**MRP** Materials Reliability Program \_\_\_\_\_ MRP 2018-003

SUBJECT: RESPONSES TO NRC REQUEST FOR ADDITIONAL INFORMATION FOR  
ELECTRIC POWER RESEARCH INSTITUTE TOPICAL REPORT MRP-227, REVISION 1,  
"MATERIALS RELIABILITY PROGRAM: PRESSURIZED WATER REACTOR  
INTERNALS INSPECTION AND EVALUATIONS GUIDELINE" (CAC NO. MF7740)

### Responses to NRC Requests for Additional Information (RAIs) on MRP-227, Revision 1

Figure 1: Approximate schematic sketch of the deep beam structure (figure from MRP-227-A)

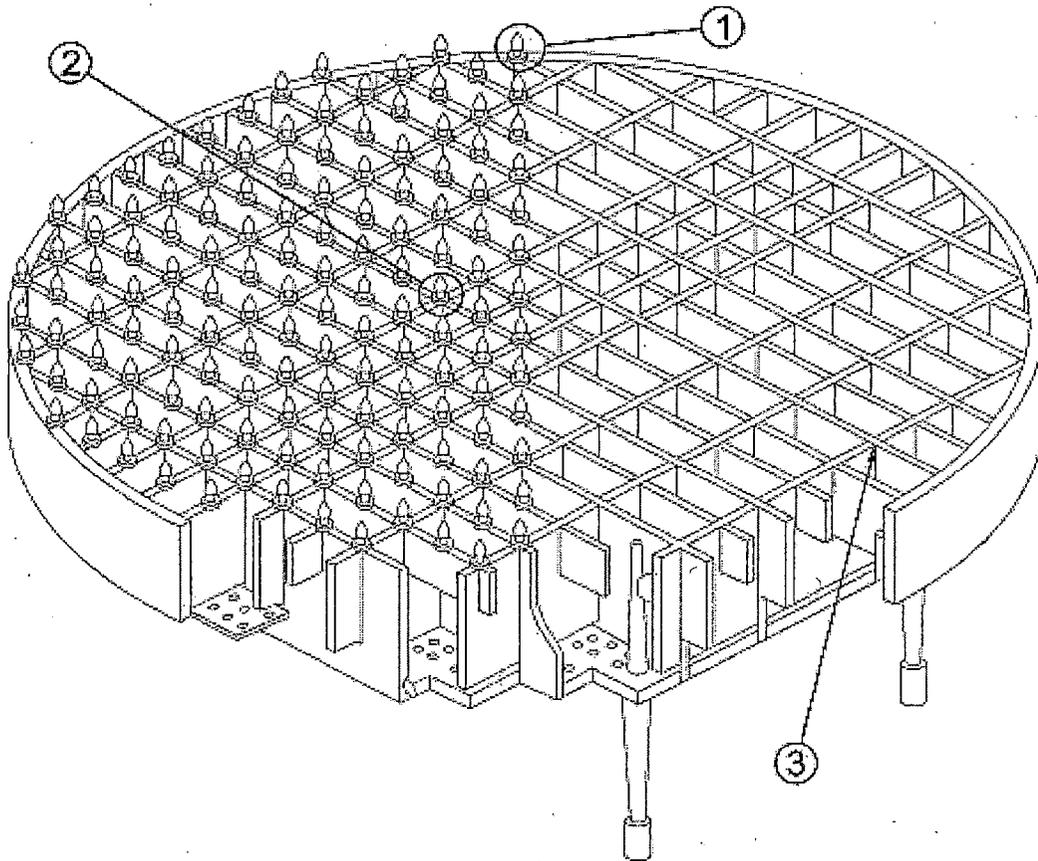
- a. Provide a justification for the reduction in coverage for these two items. The technical justification for the reduction in examination coverage should provide reasonable assurance that (1) the functionality of the components will be maintained and (2) the structural integrity of the components will be maintained to ensure safe shutdown of the reactor during the PEO.
- b. What expansion to the remaining beam-to-beam welds will be conducted if degradation is found in the initial 25 percent inspection sample?

Per MRP-227, Revision 1, the deep beams are only applicable to the CE plants with welded core shrouds assembled from full-height shroud plates. The deep beams are located directly beneath the core and the fuel assemblies sit on top of the beams. Figure 1 shows an approximate sketch of the deep beams (the same figure was included in MRP-227-A). The circles labeled "1" and "2" are the fuel alignment pins that interface with the fuel assemblies. The arrow labeled "3" points to one of the joints between the beams that make up the assembly. A full-penetration weld is located at each of these joint locations. These are the welds that are included in the Primary component inspection requirement of CE Item C12. The previous coverage requirement under MRP-227-A included all of the beam welds and required EVT-1 inspection of the top 4 inches of each weld. The coverage requirement under MRP-227, Revision 1 is to examine 25% of the total number of beam-to-beam welds, with the coverage including the top 4 inches of each weld. There is one full-penetration weld at each beam-to-beam intersection in the structure. Between 150 and 200 of these intersections/welds are expected to be accessible for the inspection, so the 25% coverage will include approximately 35 to 50 welds. At each location, this inspection

Given the number of individual welds that will be inspected for potential degradation, the redundancy in the deep beam structure, the monitoring for loss of function through fuel loading and unloading, and the applicability of the sampling approach described in MRP-227, reducing the inspections to 25% of the welds will provide adequate coverage to detect the onset of failures of significance. The reduced inspection coverage requirement of MRP-227, Revision 1 is justified for the Item C12: Deep Beams. Note that the coverage requirement will be modified to require that the inspection be spread out across the structure and be performed on different sets of welds after each inspection interval. The text for the "Examination Coverage" column of Table 4-2 in MRP-227, Revision 1 will be revised as follows:

- o Note 8 will also be added to the Examination Coverage of the table entry: “8. Justification that adequate distribution of the inspection coverage has been achieved can be based on geometric or layout arguments. For example, since each rectangular axial compartment in the structure has four welds around it, which are shared with the adjacent compartments on two sides, the inspection coverage could consist of the selection of one weld from every second compartment in the structure.”

Primary Item	Applicability	Effect (Mechanism)	Expansion Link (Note 1)	Examination Method/Frequency (Note 1)	Examination Coverage
C12.Lower Support Structure Deep beams	Only plants with welded core shrouds assembled with full-height shroud plates	Cracking (Fatigue) that results in a detectable surface-breaking indication in the welds or beams. Aging Management (IE)	None	Enhanced visual (EVT-1) examination, no later than 2 refueling outages from the beginning of the license renewal period. Subsequent examination on a ten-year interval, if adequacy of remaining fatigue life cannot be demonstrated.	Examine 25% of the total number of beam-to-beam welds. Coverage on each weld examined includes the top four inches of the weld in the vertical orientation. <u>The inspection coverage must be evenly distributed across the deep beam structure.</u>  (Notes 6, 7 and 8)  See Figure 4-344-33.
